Comment Letter No. 09

February 13, 2017

Re: Newhall Ranch Draft Additional Environmental Analysis for the Newhall Ranch Resource Management and Development and Spineflower Conservation Plan Environmental Impact Report (SCH No. 2000011025)

Figure 1. Seasonal Flow Conditions and Timing of Construction Activities

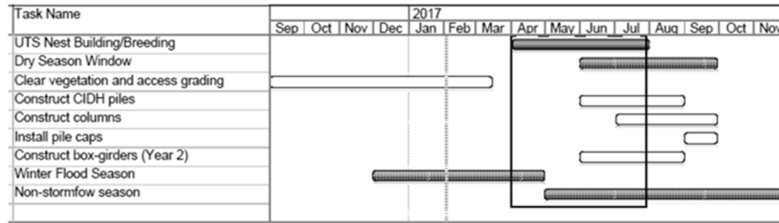
3. Identification of any new environmental impacts - The wetted channel is defined based on surface topographic conditions; however, it is not clear if hyporheic zone investigations have been made to understand the potential groundwater connections between the wetted channel and the dry riverbed where grading will occur. The concern is if physical impacts to the UTS may occur during their nest building or breeding season (Figure 1) via construction intrusions into the

hyporheic zone, below the water table, where UTS may inhabit wetted interstitial spaces between riverbed sediments.

Figure 2. Santa Clara River Streamflow Duration Hydrograph

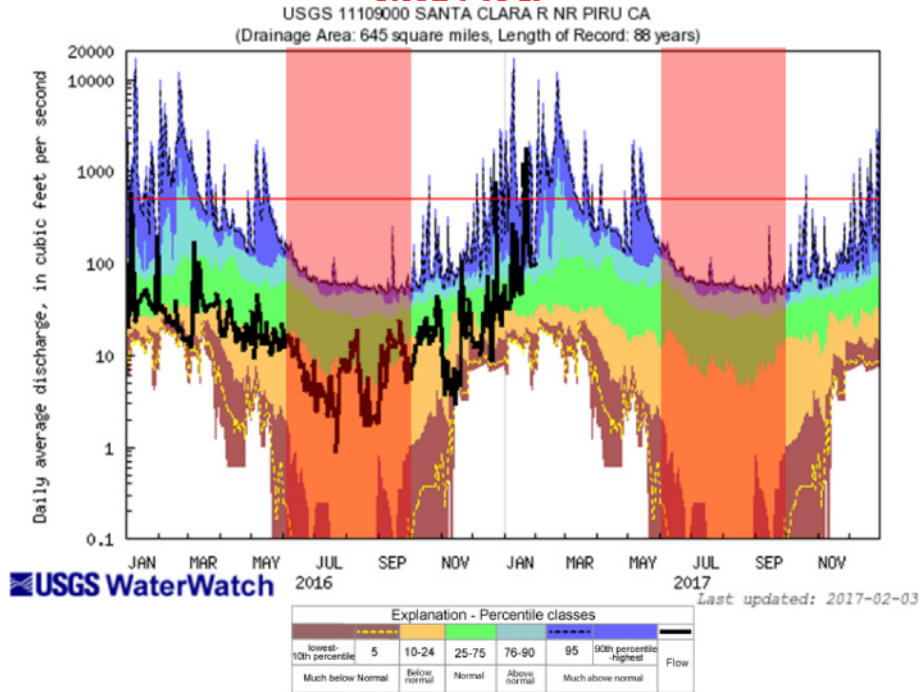
- Figure 2 shows the last 2 years of recorded flow data (black line) for USGS gage 11109000, the June through September dry season construction windows (pink boxes), and the 500 cfs value (red line). The colored areas show long-term statistics of streamflow for each day of the year at that station and the top of the dark blue area represents the maximum discharge recorded during the period of record for each day of the year. The 500 cfs flow rate appears to be a reasonable flow rate for establishing the wetted channel area.
